Brightlingsea
Harbour
Commissioners

Morgan Marine Planning Application
User Group Hazard and Risk Assessment -
Safety of Navigation

Leisure Users - Bathymetric Information

East Basin – Proposed pontoon – To establish 42m clearance

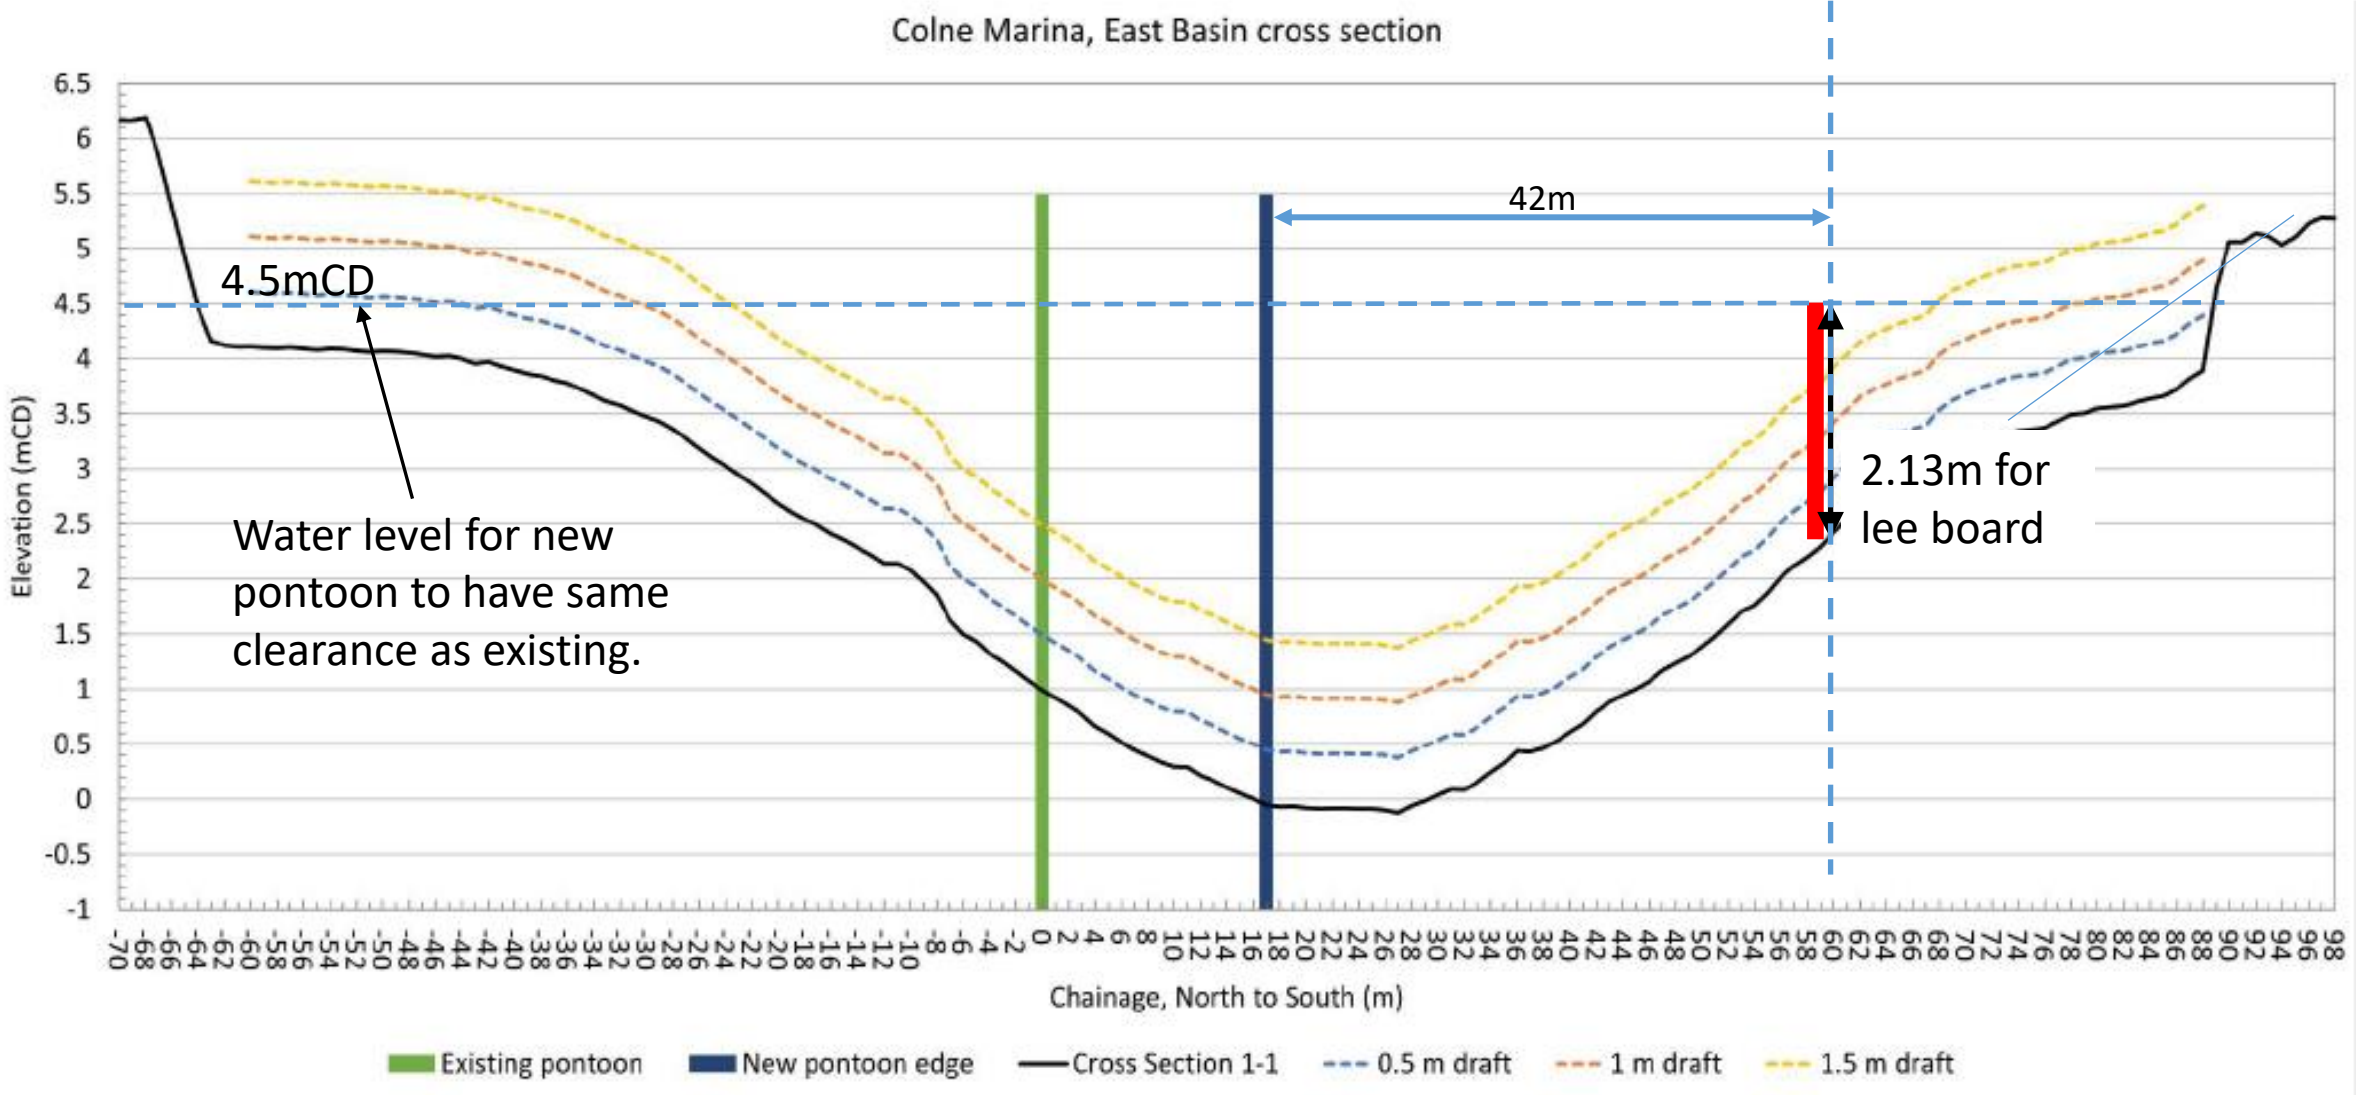
- For the existing pontoon the 42m safe passage requires a tide level of 2.8mCD at 2hr 40min before high tide.
- For the proposed pontoon the 42m safe passage requires a tide level of 4.5mCD at 1 hr before high tide.
- On Spring tides – delay is 1hrs 40min.

Neap tides –

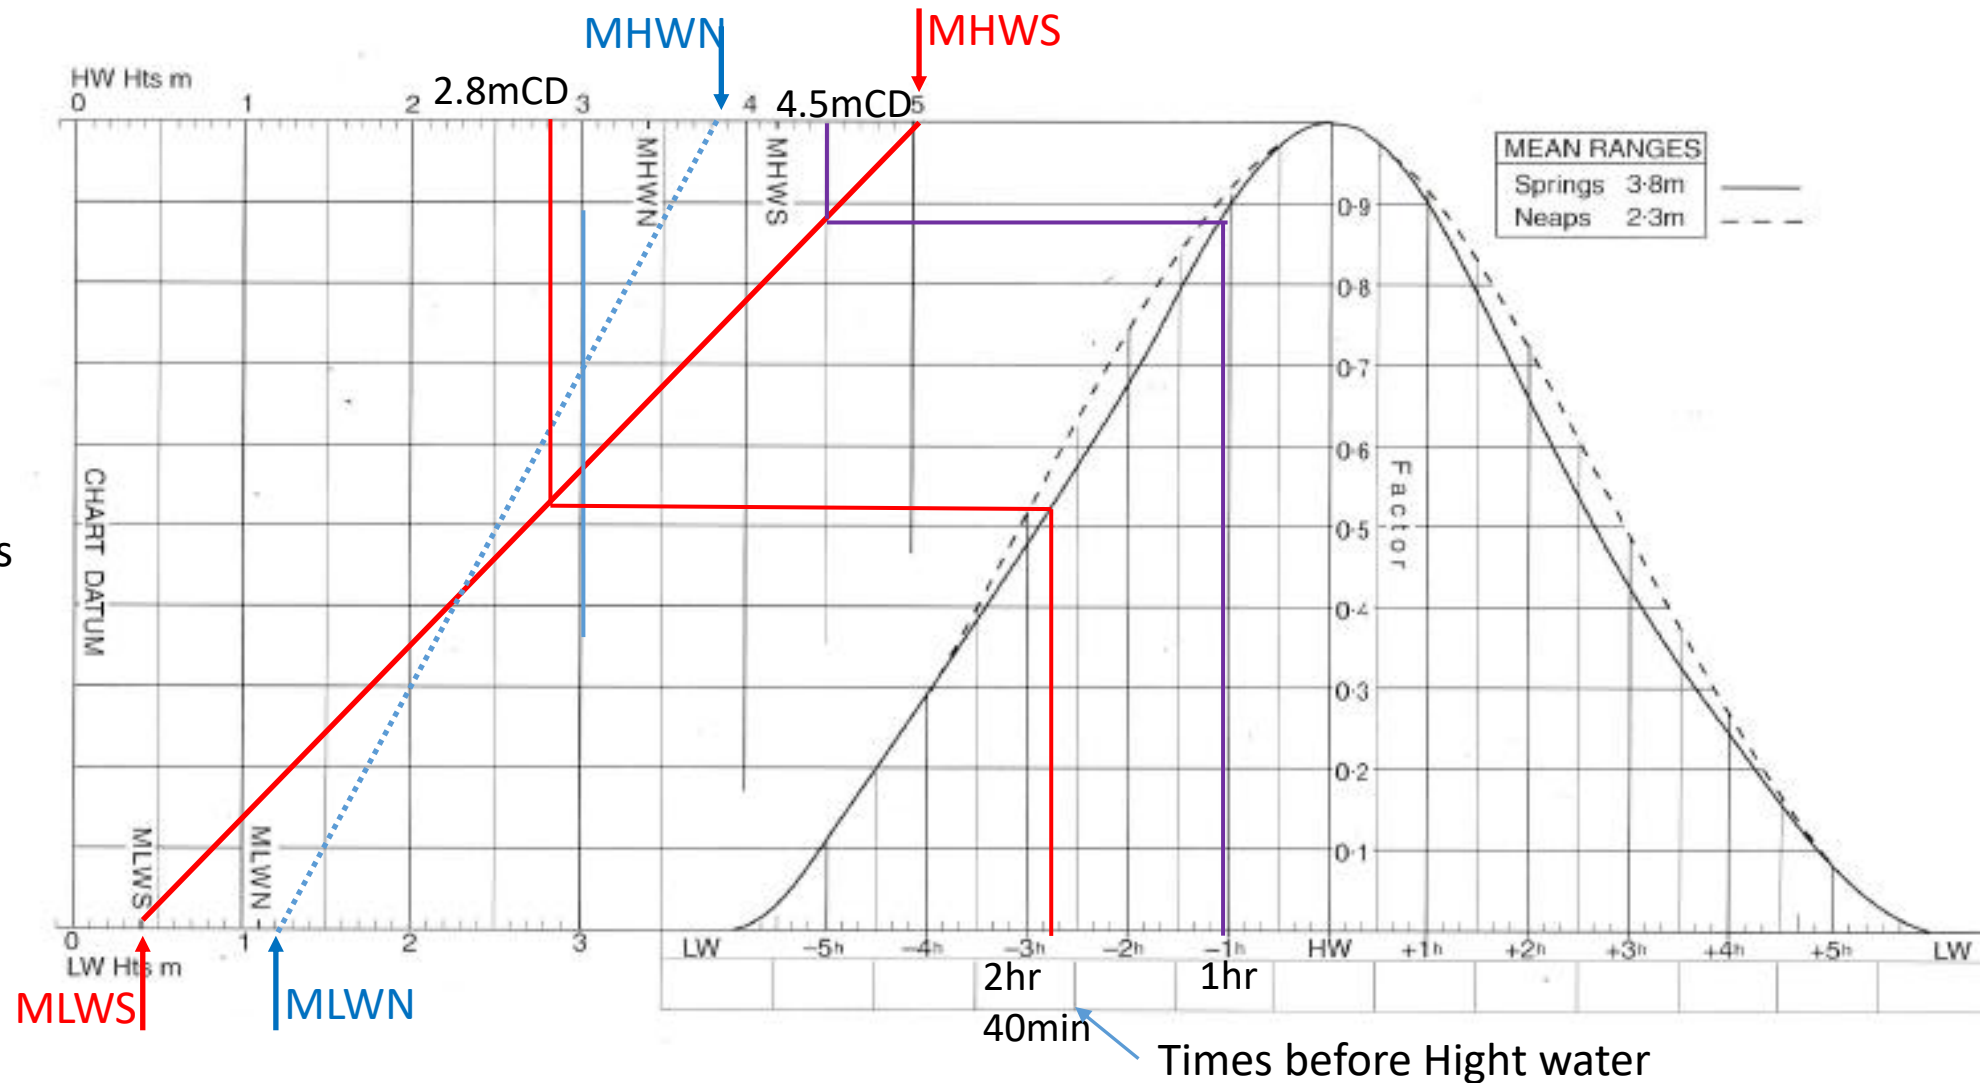
- The barge cannot pass the proposed pontoons at neap tides.
